PLANNING & ZONING
November 05, 2026
5:30 PM
City Hall

MILLS CITY PLANNING COMMISSION

City of Mills Planning Department — Subdivision Review, Findings and Considerations

Wyoming Classical Academy Phase II Development Plan

PROPERTY LOCATION PLAT

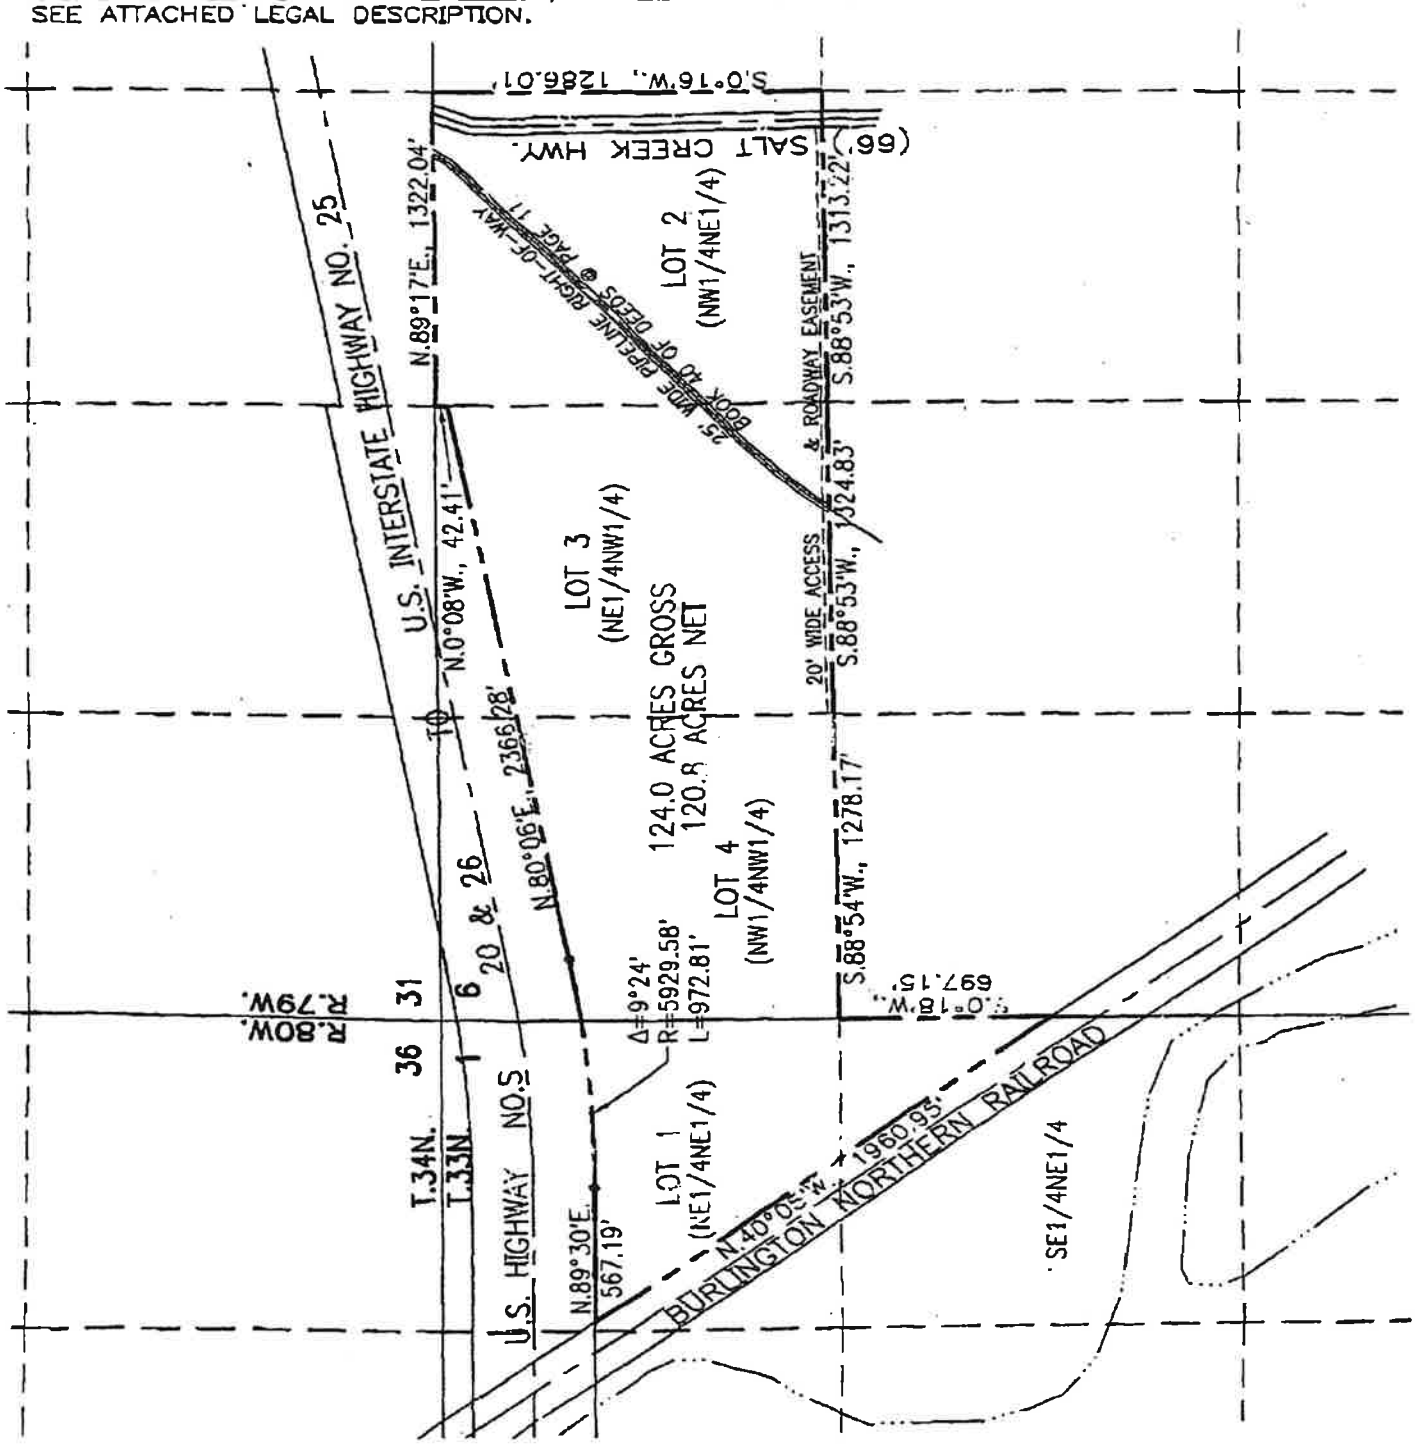
47.55.030(1)(p)(ii)	Curve data	R=60.00', L=303.50', Δ=289°49'29", chord shown with record values	Complies
47.55.030(1)(p)(iii)	Existing and proposed easements, use and size	All shown with use and width; one 30' access easement has no recording reference	Complies; add recording reference

1. **Lot 7 Frontage.** Dimension the width of M-J-B Road at its west end and Lot 7's frontage on it (§47.55.030(1)(p)(i)). Label the adjoining flag pole of Lot 2, Tetral Subdivision No. 1, to the north (§47.55.030(1)(q)). Show the recording reference for the 30' access easement in Lot 7's northeast corner, and state whether it remains or is released (§47.55.030(1)(p)(iii)).
2. **Easements.** Show a 10' general utility easement along Lot 7's street-side lot line on M-J-B Road (§47.55.030(1)(k)(iii)).
3. **Execution.** Complete all signatures and notary acknowledgments before recording.

SHEET
L1.0

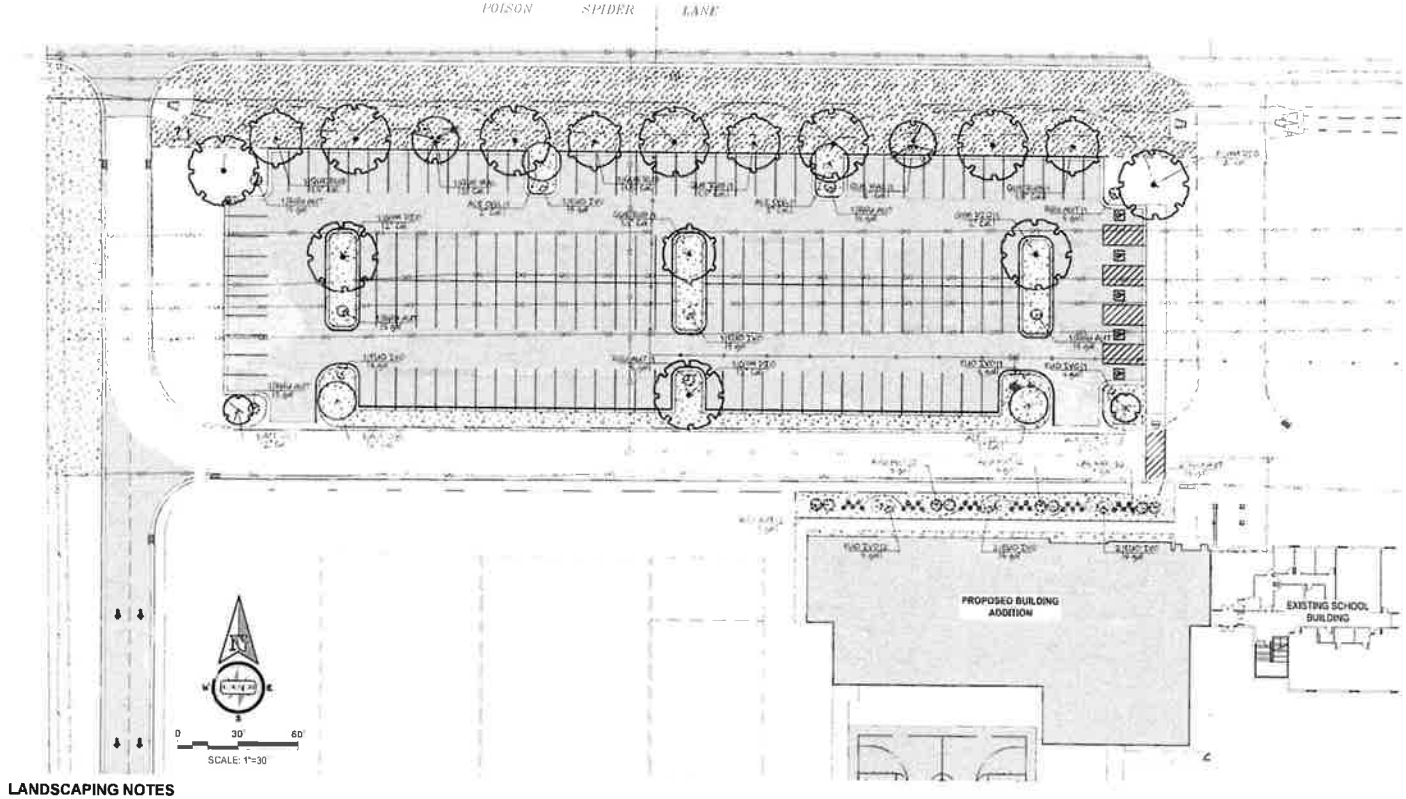
8. Island planting: The tree and shrub in each parking island, with species, size, and quantity. Show the gas lines that cross the islands and state what will be planted where a line limits planting.
8 Response: See updated sheet L1.0

9. Park strip planting: The park strip planting from Sheet C500 carried onto the landscape plan, with species, size, and quantity.
9 Response: Planting is located on the south side of the park strip between parking lot and drainage ditch. See updated sheet L1.0

8	Island planting	Tree and shrub in every island, with species, size, and quantity (§40.40(7)(d)(ii)); gas lines shown.	Resolved
9	Park strip planting	5-ft. perimeter strip planted (§40.40(7)(e)); ROW planting not required.	Resolved
10	Irrigation	Irrigation committed by L1.0 Note 4 (§40.40(7)(h)); layout not required at DP stage.	Resolved
11	Existing vegetation	None retained or credited.	Resolved
12	Lighting layout	Fixture locations, heights, shielding, and aiming shown (E101).	Resolved
13	Photometric grid	Extended 5 ft. past north and west lines; 0.08 fc max.	Resolved
14	All fixtures in calculations	Included (E102).	Resolved
15	Pole and base heights	15-ft. poles; 17 ft. AG (E501, E602).	Resolved
16	House-side shielding	Specified on north and west fixtures (E101).	Resolved
17	Controls	Astronomic time clock (§40.35(3)(a)).	Resolved
18	Cut sheets	Provided for all exterior fixtures.	Resolved
19	Narrative	Provided (§40.35(4)(a)(v)).	Resolved

7. Updated landscape plan: A current Sheet L1.0 that matches the redesigned site layout and shows items 8 through 11.
7 Response: See updated sheet L1.0

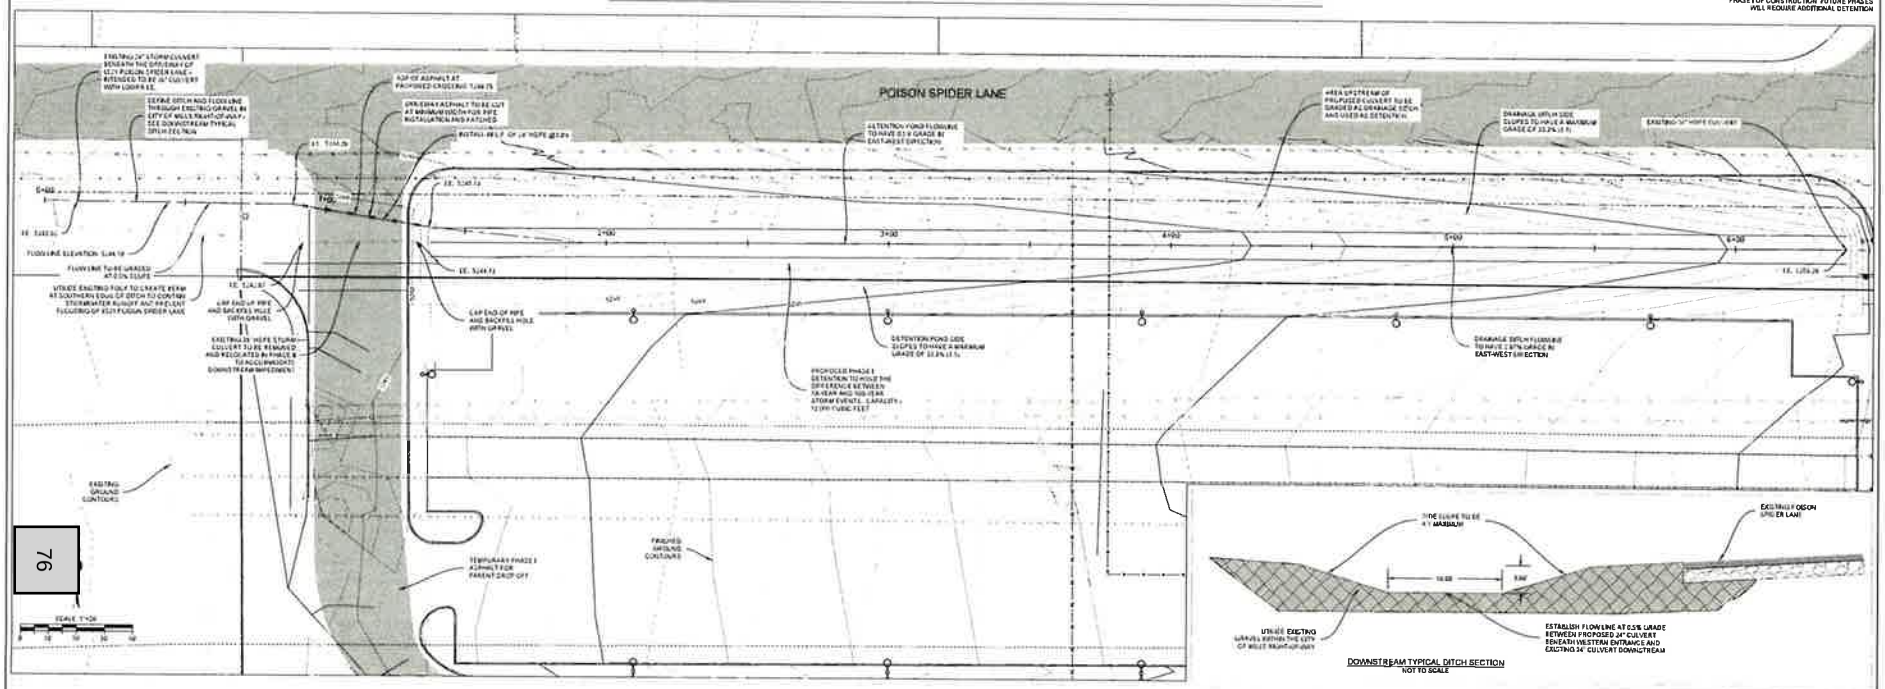
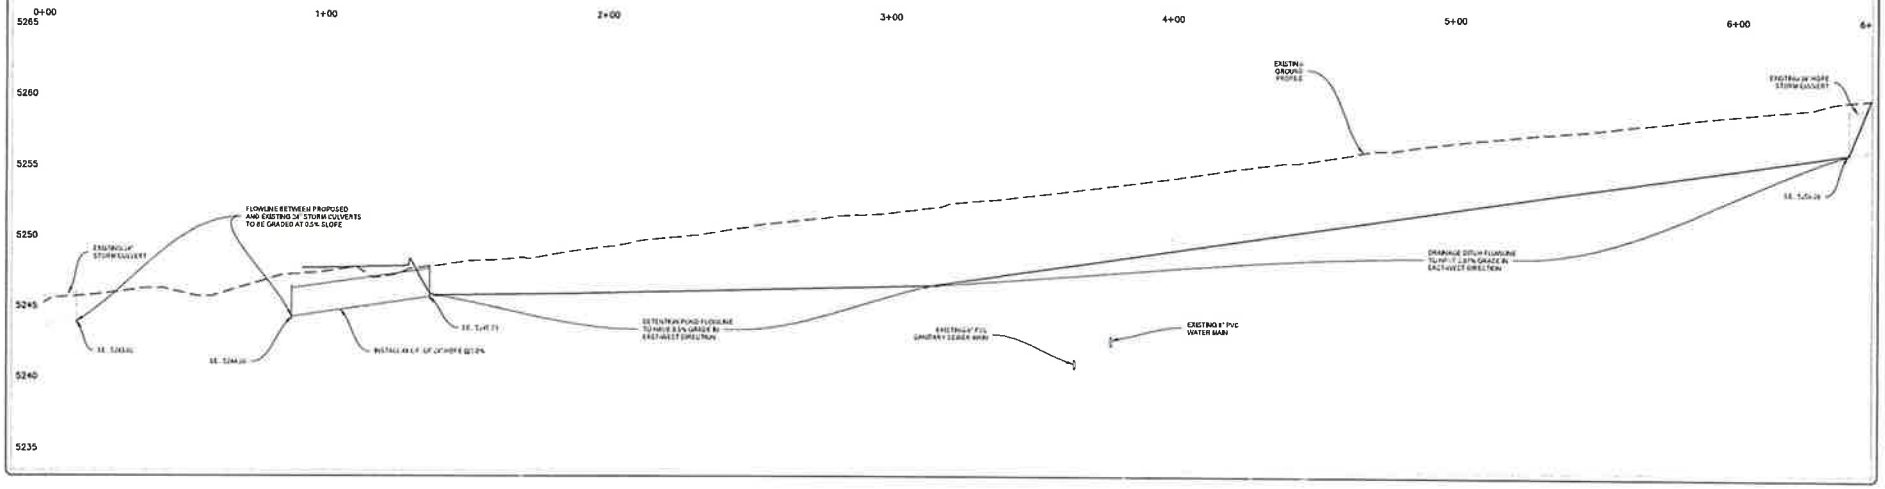
Section 10.40(7)(e) requires a drainage plan that shows surface drainage and its effect on the site and on abutting public and private property. The Commission asked for ditch and culvert capacity, swale storage, downstream impacts, the change in drainage area, pond routing, and an indexed drainage map (Items 1–6).

The ECS letter (October 23, 2026) models the 6.57-acre Phase II catchment and calls for 6,675 cu. ft. of detention. It recommends using the 737 cu. ft. remaining in the Poison Spider Lane pond plus 5,938 cu. ft. of new detention on site. The plan set provides +7,320 cu. ft. of expanded detention along Poison Spider Lane, which is more than recommended. The former 24-in. culvert has been replaced with 36-in. HDPE, with a capacity of 122.6 cfs against a 100-year peak of 97.4 cfs at the swale. Post-detention flows continue through existing infrastructure to the Platte View Estates pond.

The City Engineer has accepted the drainage material in the plan set, using the detailed elevations as the basis for approval. The City Engineer also cited the additional detention along Poison Spider Lane as a factor in reducing off-site impact through staged storage. Staff finds Items 1–6 resolved and the requirements of §10.40(7)(e) and §10.40(2)(g) met.

Although 7,017 cubic feet of detention is available between the two detention ponds on the site, routing of stormwater runoff to the detention pond on the western edge of the property may be difficult given the infrastructure proposed as part of this phase of development. Therefore, ECS Engineers recommends utilizing the 737 cubic feet available in the Poison Spider Lane detention pond, and providing an additional 5,938 cubic feet of detention on site for Phase II of Wyoming Classical Academy.
